Project No. 15-004-01

Subject: CalAm Monterey Peninsula Water Supply Project, Draft Environmental Impact Report/Environmental Impact Statement, Prepared for California Public Utilities Commission and Monterey Bay National Marine Sanctuary, January 2017.

As requested, Hopkins Groundwater Consultants, Inc. (HGC) has reviewed the hydrogeology-related and alternatives portions of the Cal-Am Monterey Peninsula Water Supply Project (MPWSP or the “project”) Draft Environmental Impact Report/ Environmental Impact Statement (DEIR/EIS) prepared for the California Public Utilities Commission, dated January 2017, and is providing these comments for Marina Coast Water District’s (MCWD) consideration and use. In preparing these comments, we have reviewed the relevant portions of: (1) the DEIR/EIS; (2) the DEIR/EIS appendices; (3) references cited in the DEIR/EIS and DEIR/EIS appendices; (4) the calibrated model developed for the MPWSP and the application of the superposition model scenario constructed to evaluate the project; (5) the documents provided to HGC in response to MCWD’s data and public records act requests that were made available before March 27, 2017; and (6) publicly available in

**Diagram 1 – Conceptual Hydrogeology of Marina Subarea**

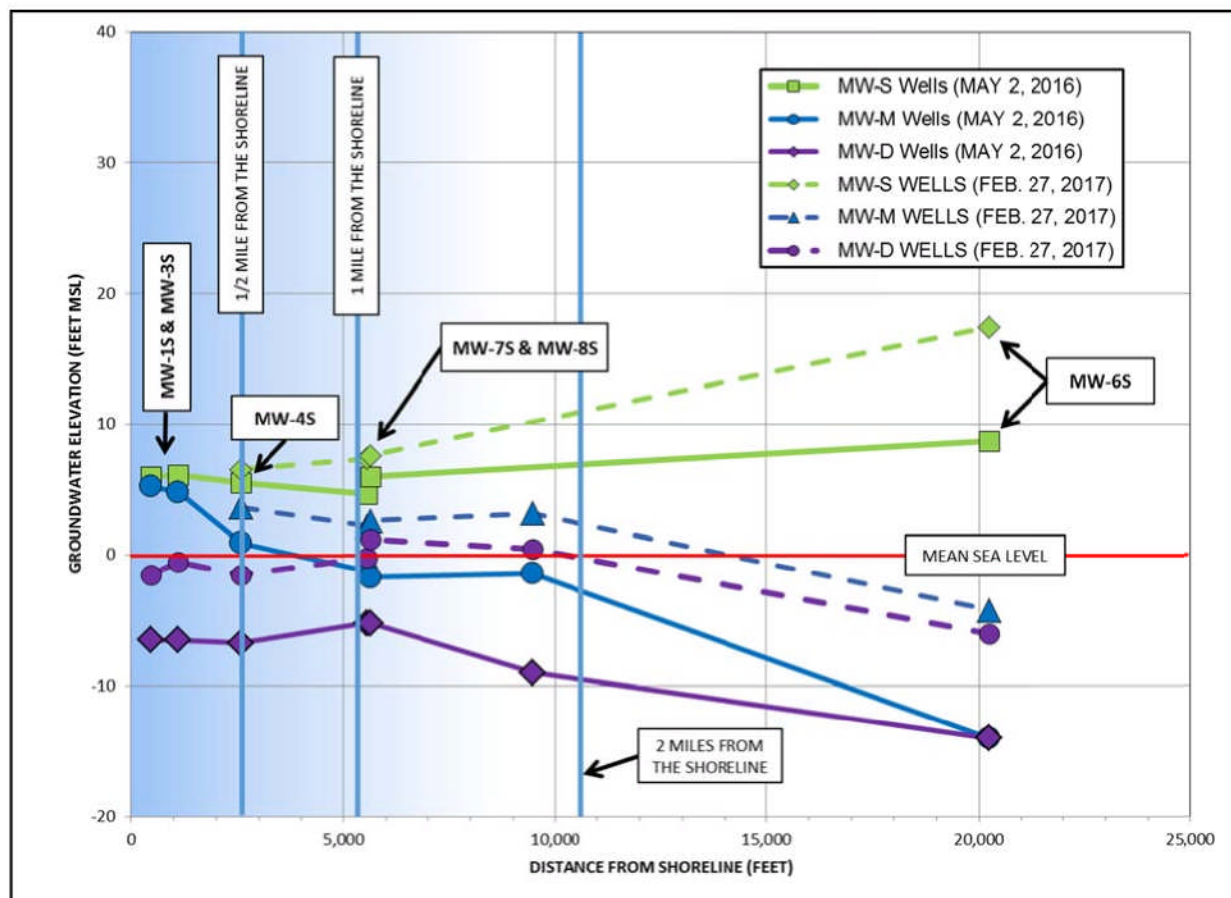
As discussed in detail below, the pre-project studies indicate that MW-1S, MW-3S, MW-4S, and MW-7S likely are connected to the Dune Sand Aquifer zone recognized as the -2-Foot Aquifer that is identified beneath the County landfill site (Geoscience, 2016). The elevation and thickness of this zone indicates it likely has a hydraulic continuity to the A-Aquifer zone in the main portion of the SVGB located north of the river. The concept demonstrated by these data is further illustrated on Diagram 1 – Conceptual Hydrogeology of Marina Subarea along with the perched Dune Sand Aquifer condition.

Also discussed below, recent data obtained regarding the gradient beneath the landfill (near MW-5) shows recharge from the river that creates a groundwater gradient toward the coastline. Importantly, this is consistent with the elevated heads in MW-6S where it also receives recharge from the river. Diagram 2 – Water Level Elevation and Shoreline Proximity compares available data that were collected just prior to restarting the long term pumping test on May 2, 2016, and the high water level conditions observed on February 27, 2017. This diagram shows the wells that are constructed in the Dune Sand Aquifer zone that is equivalent to the -2-Foot Aquifer zone along with MW-6S, which is in the A Aquifer zone (Geoscience, 2016). As shown by these data, there is a groundwater gradient that moves water from the river area of recharge toward the coastline in the Marina Subarea of the SVGB. Monitoring Well MW-5S data with water levels in excess of 35 feet amsl were not included in Diagram 2 because it is now recognized to be screened in a semi-perched dune sand layer on top of the aquitard layer identified as the Fort Ord Salinas Valley Aquitard (FO-SVA). The FO-SVA layer overlies the -2-Foot Aquifer/Dune Sand Aquifer, which is reportedly 30 to 40 feet thick and rests on the Salinas Valley Aquitard near the river in the Marina Subarea northeast of the project site (Geoscience, 2016).

**Diagram 3 – Particle Tracking With No Background Gradient**

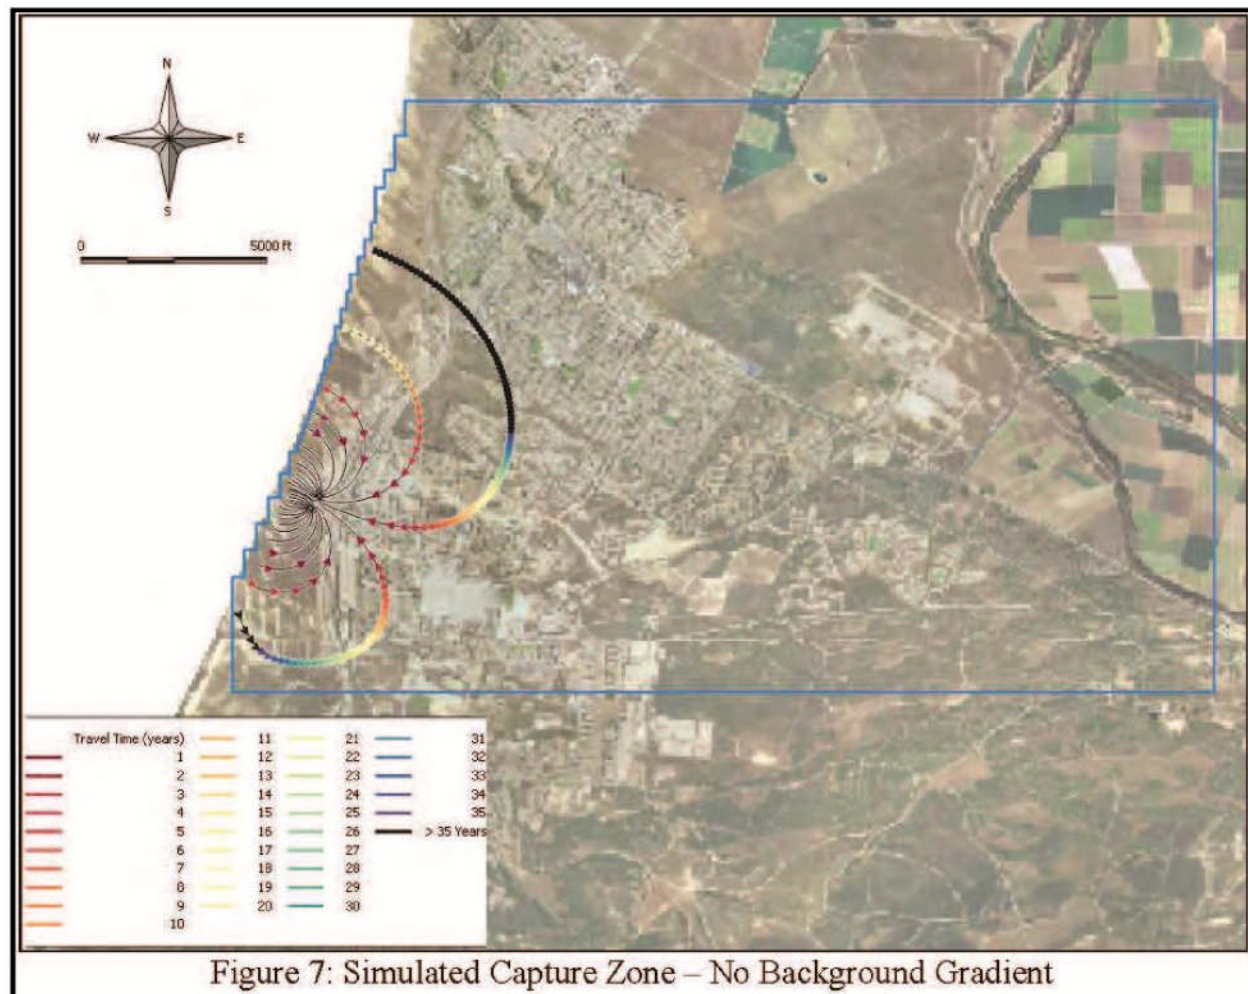
Again, this failure is fatal to the DEIR/EIS's ability to reliably analyze the project's potential groundwater impacts. Given the potential magnitude of the increased groundwater production, the impacts to the SVGB, in particular the Marina Subarea, the project's potential impact on the Marina Subarea are very likely grossly understated by the superposition model. Therefore, a well calibrated model is needed to quantify the project's potential impacts with a reasonable scientific basis. Specifically, a model that utilizes all the recharge and discharge components included in the older SVIGSM, and constructed with a level of detail reflecting our present understanding and knowledge of the hydrogeological system in the Marina Subarea is needed. Moreover, because seawater is an issue, a dual density model should be used to allow calculation of the head differences between the ocean water offshore and onshore, and freshwater in the aquifer zones inland and to allow prediction of water quality changes and the concentrations of feedwater that would be produced by the proposed project.

**Diagram 4 - Particle Tracking With  
8-Foot Gradient Across Model Domain**

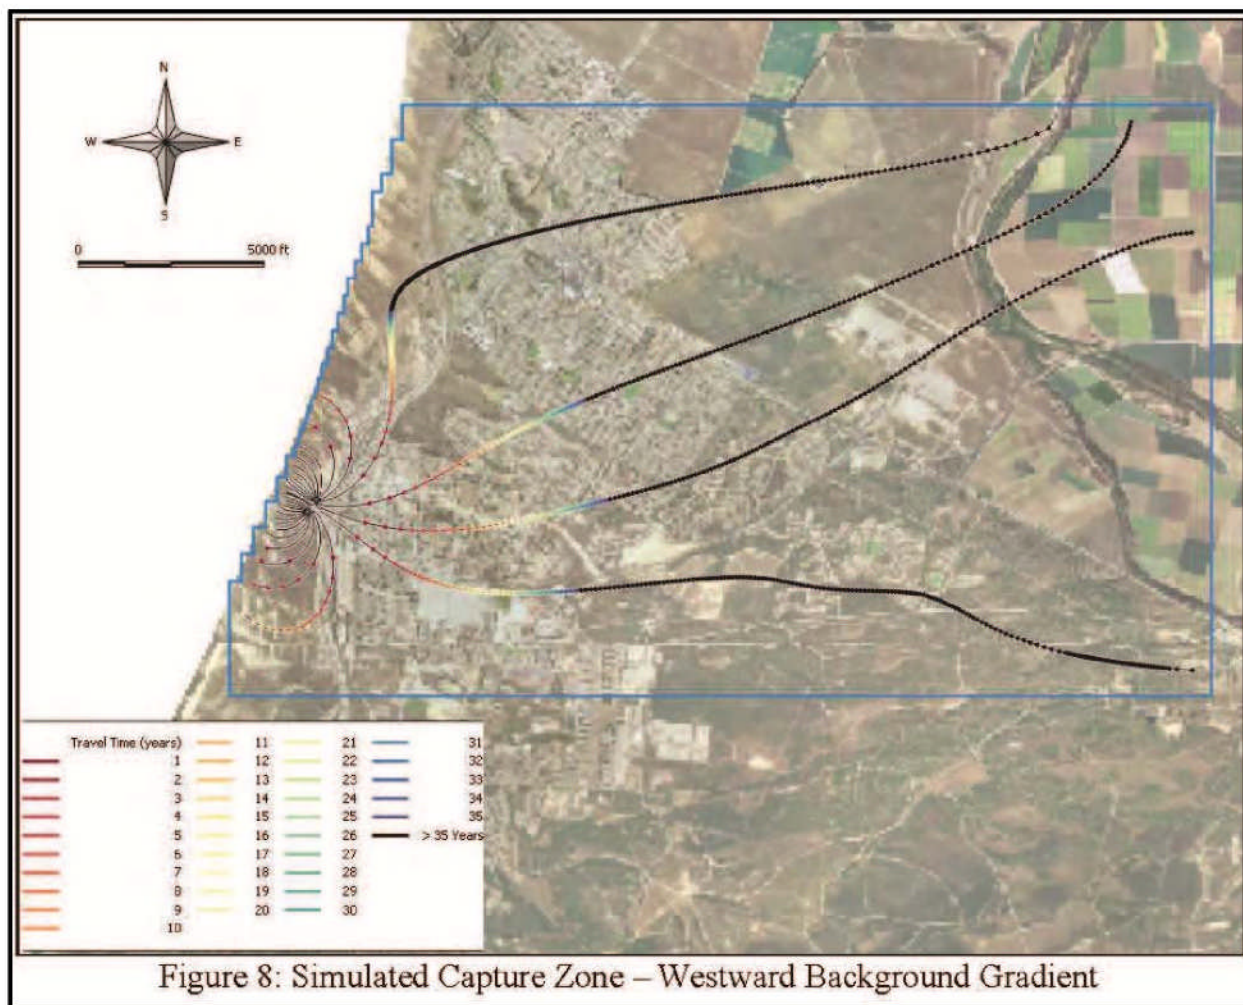
With this understanding of perched groundwater conditions within the Dune Sand Aquifer in the Marina Subarea and with the fundamental flaws in the DEIR/EIS's modeling, we offer the following specific comments on the DER/EIS. To simplify the presentation of our comments and assist your review of these pertinent issues, we have excerpted or summarized the sections of the DEIR/EIS that we address and subsequently provide our comments or concerns of the hydrogeological issues that are crucial to understanding the potential project impacts. Please note that while we have selected certain sections of the DEIR/EIS to comment upon, our comments apply to similar statements that are repeated in other sections of the DEIR/EIS.

**Diagram 5 – Percent Groundwater and Ocean Water with Distance from the Shoreline**

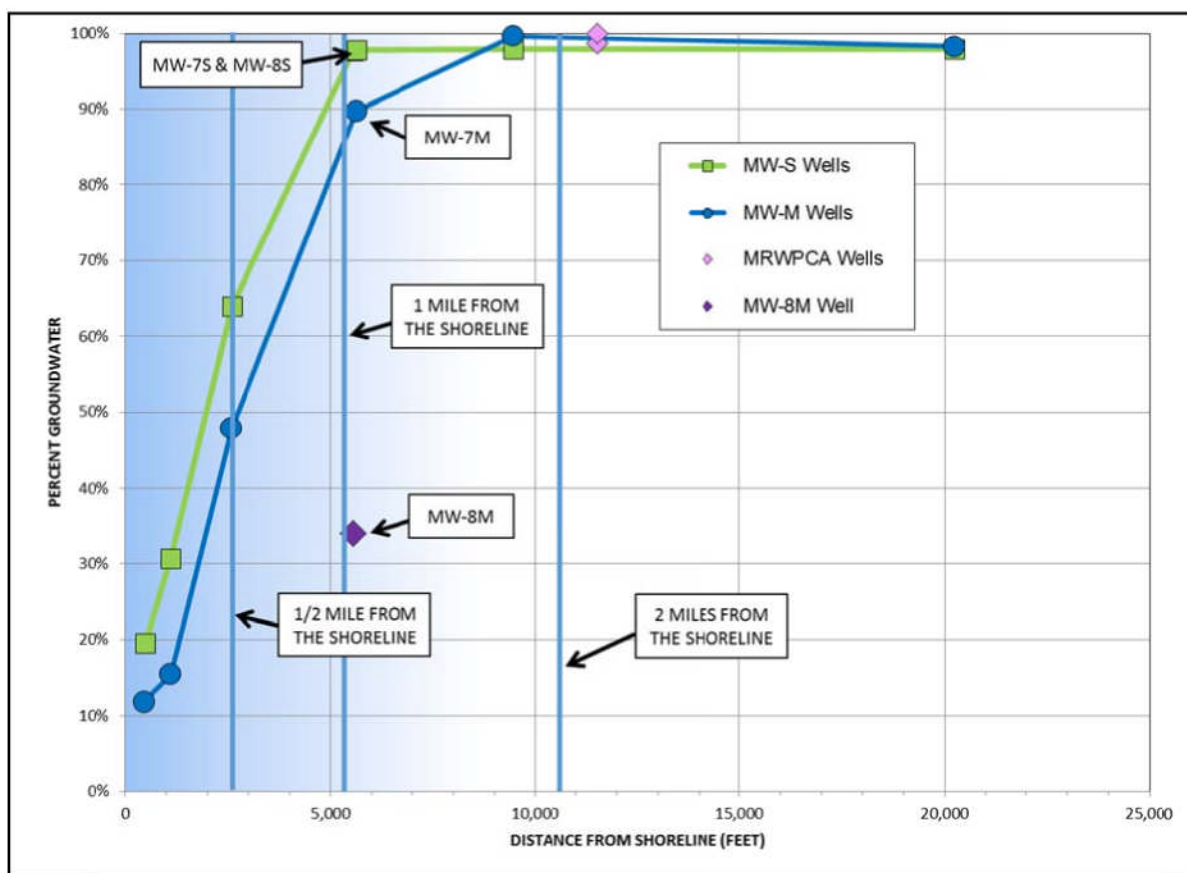
As noted above, the MCWRA maps used to justify the DEIR/EIS position are included with this response letter and include recent data from the TSW project that contradict the blanket statement that the freshwater/seawater interface is 8 miles inland (see attached Figures 1 through 5 and Diagram 5). Moreover, MCWRA does not have any maps for the extent of seawater

**Diagram 6 – Original Test Slant Well Design Evaluated by SWRCB**

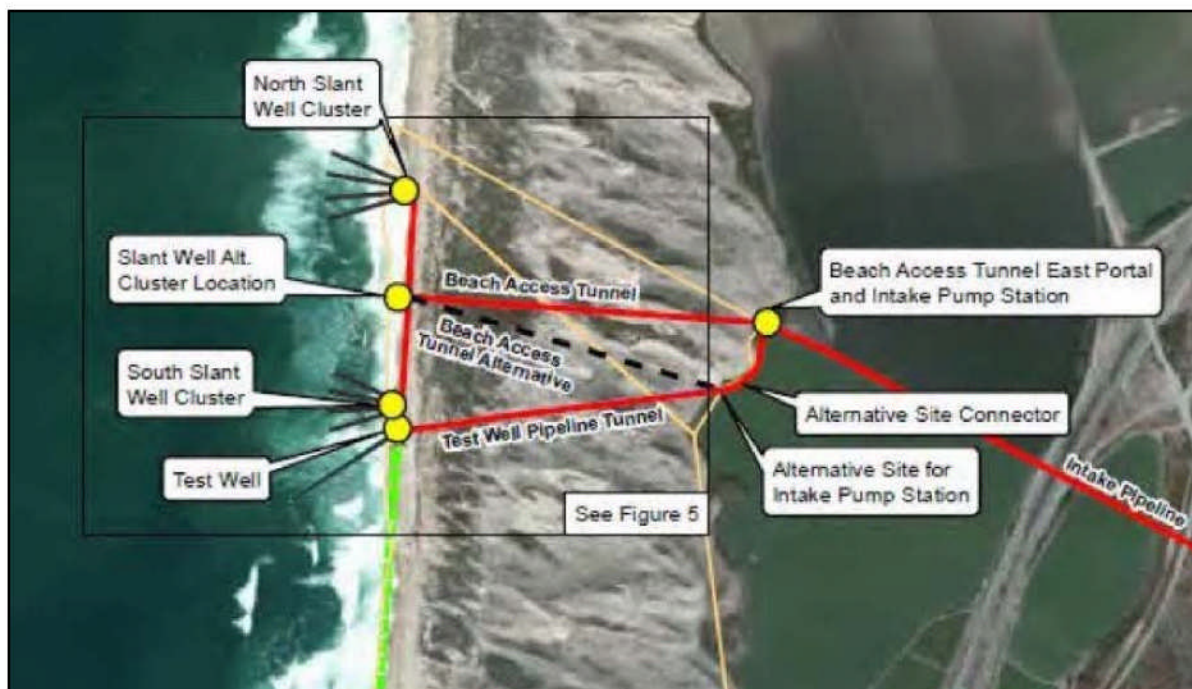
First, the DEIR/EIS presents inconsistent and misleading language regarding the location of the well screens. As the DEIR/EIS preparers are aware, the project's slant well locations have moved significantly landward when compared to the originally proposed project intake location evaluated by the SWRCB (see Figure 4, SWRCB, 2013). The conceptual location and design of the original slant well seawater intake system array is shown in Diagram 6 – Original Test Slant Well Design Evaluated by SWRCB. Contrary to this original design, the proposed slant well designs and locations disclosed in the DEIR/EIS indicate a majority of the well screen sections are now located landward of the shoreline. In addition, only the deepest portions of the well screens would potentially be located beneath the ocean floor with the shallower well screen intervals producing from the Dune Sand Aquifer and located onshore (see DEIR/EIS, Chapter 3, Figures 3-3a and 3-3b, and Table 3-2). Thus, the project does not appear to comply with the MCWRA Agency Act (also see details on, Geoscience, 2015a, Figures 47, 48, and 51 to 69) as the DEIR/EIS suggests. The DEIR/EIS must be revised to address consistency with the Agency Act based on the percentage of the well screens for each test well that has screened intervals located landward of the beach mean high water line to assess consistency with the MCWRA Agency Act. It is also not clear if the SWRCB would have arrived at the same conclusions if it had been reviewing the presently proposed intake design.

**Diagram 7 – CEMEX Surface Water Features August 2013**

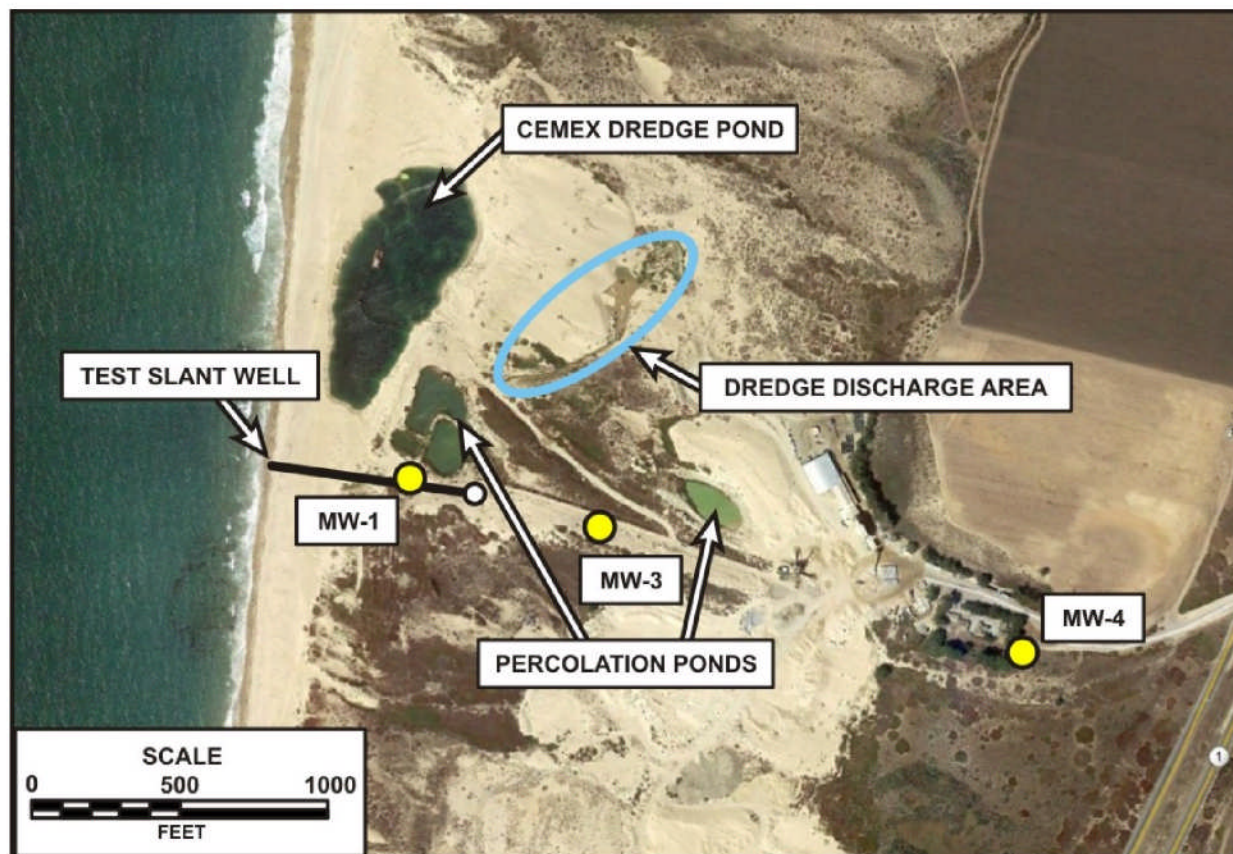
These localized sources of salt water shown in Diagram 7 significantly influence the quality of the shallow groundwater that is observed in MW-1, MW-3, MW-4 and produced by the test slant well. The results in an overestimation of the seawater component flowing landward from the shoreline and an under estimation of the return water that will be required for mitigation.
